Access Compliance Report

Public Rights-of-Way

Intersection ID: 29695	Main Street: BIG_PINE_DR	Cross Street: WOODCROFT_WY	Location: S
ADA ID: 7CB682797004	Ramp Type: PerpDiag	Initial Pass/Fail: Fail	Overall Compliance: No
			Severity Score: 21.25

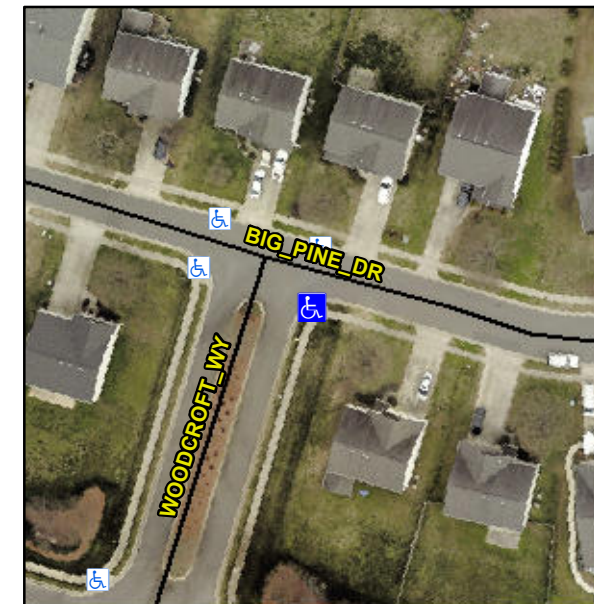
Not Found, R304.5.1, R304.5.3

Compliance	Description	Data	Compliance	Description	Data
N/A	Ramp Length (in)	44.5	Yes	Ramp Slope (%)	8.3
No	Ramp Width (in)	44.0	No	Ramp XSlope (%)	5.1
N/A	Flare Type LT	N/A	N/A	Flare Type RT	N/A
N/A	Flare Slope LT (%)	N/A	N/A	Flare Slope RT (%)	N/A
N/A	Flare Traversable LT?	N/A	N/A	Flare Traversable RT?	N/A
N/A	Landing Length (in)	N/A	N/A	DWS Provided?	N/A
N/A	Landing Width (in)	N/A	N/A	DWS Contrast?	N/A
N/A	Landing Slope (%)	N/A	N/A	DWS Length (in)	N/A
N/A	Landing X Slope (%)	N/A	N/A	DWS Full Width?	N/A
N/A	Landing Curb? (Y/N)	N/A	N/A	DWS Offset (in)	N/A
N/A	Shared Landing?	N/A			
N/A	Gutter Ponding?	N/A	N/A	Gutter Slope (%)	N/A
N/A	Gutter Lip Ht (in)	N/A	N/A	Gutter X Slope (%)	N/A
N/A	Painted X Walk1?	No	N/A	Painted X Walk2?	No
	X Walk 1 Direction	To NE		X Walk 2 Direction	To NW
N/A	X Walk 1 Width (in)	N/A	N/A	X Walk 2 Width (in)	N/A
	X Walk 1 Slope (%)	3.0		X Walk 2 Slope (%)	0.5
	X Walk 1 X Slope (%)	0.2		X Walk 2 X Slope (%)	6.1

Remove & Replace Curb Ramp With Two New Directional Ramps or Equivalent.
